**PG&E National  
Energy Group**

RE: Cedar Bay Cogeneration Facility  
Co-firing Petroleum Coke with Coal  
Revision of PSD-FL-137A

**Project:** Petroleum Coke - PSD Permit Modification

SUBJECT: Cedar Bay Generating Company, L.P.  
Petroleum Coke - PSD Permit Modification  
DEP File No. PP 88-24 (PSD-FL-137)

Figure 5

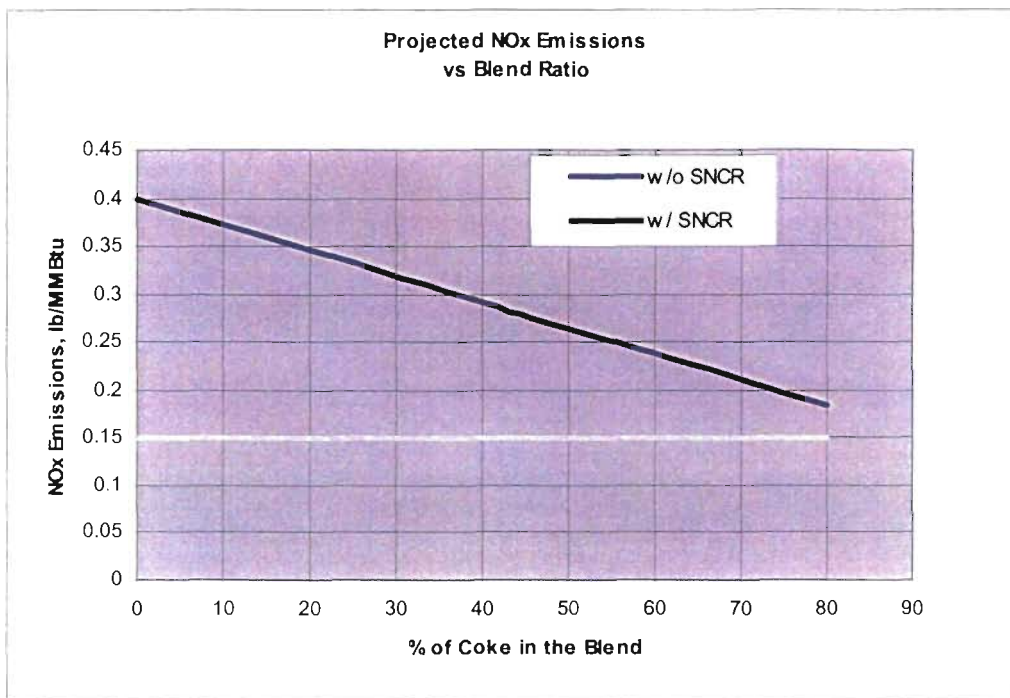
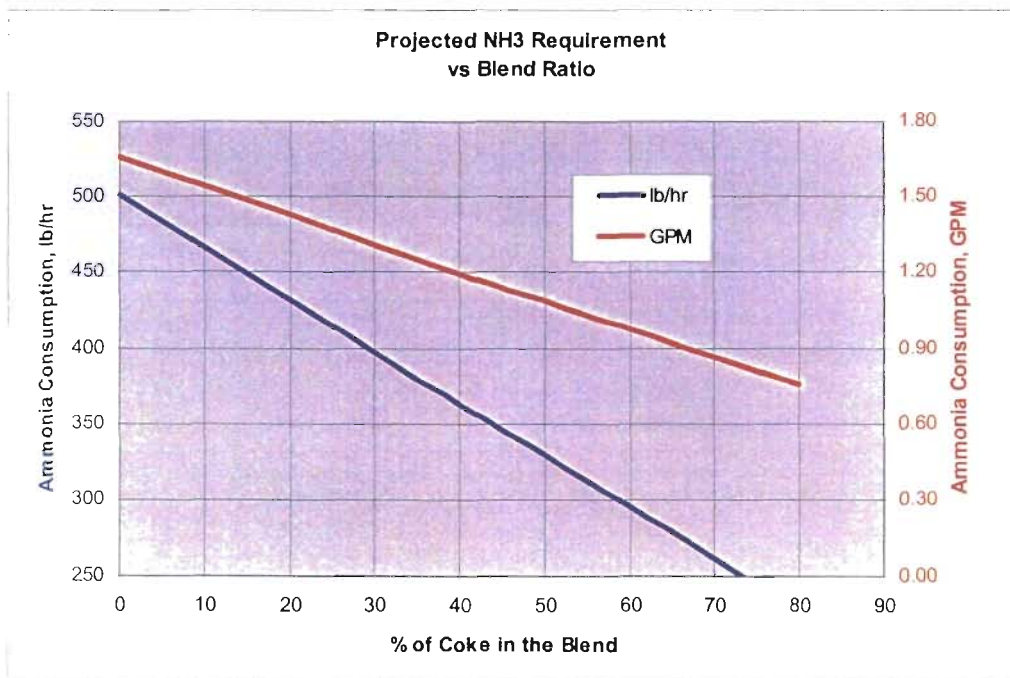
- CO – The calculated emissions are based on projections of Foster Wheeler. As shown there is a net emission decrease.
- NO<sub>x</sub> – Each CFB is equipped with Selective Non-Catalytic Reduction (SNCR), which will be used to limit NO<sub>x</sub> emission rates to levels that would not increase annual emissions above the PSD significant emission rate of 40 tons/year. As noted from the Foster Wheeler report the co-firing of petroleum coke with coal would reduce uncontrolled emissions by about 25 percent (Figure 5) with the benefit of lower ammonia usage (Figure 6).
